Appl.No. 10/709,068

Amdt. Dated Oct. 18,2004

Reply to Office action of August 25th 2004

#### **REMARKS/ARGUMENTS**

Appl.No. 10/709,068
Amdt. Dated Oct. 18,2004
Reply to Office action of August 25th 2004
Amendments to the Drawings:

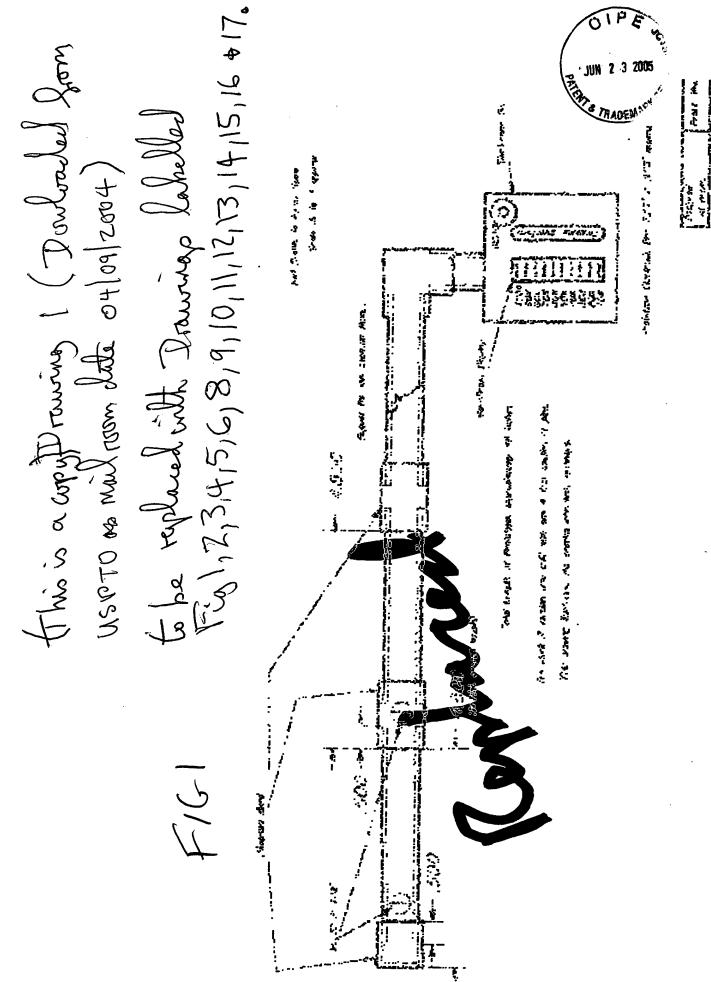
FIG 1 & FIG 2, that were deemed to be inadequate in the original submission, have been amended to the following set of drawings and will replace all prior versions in the application
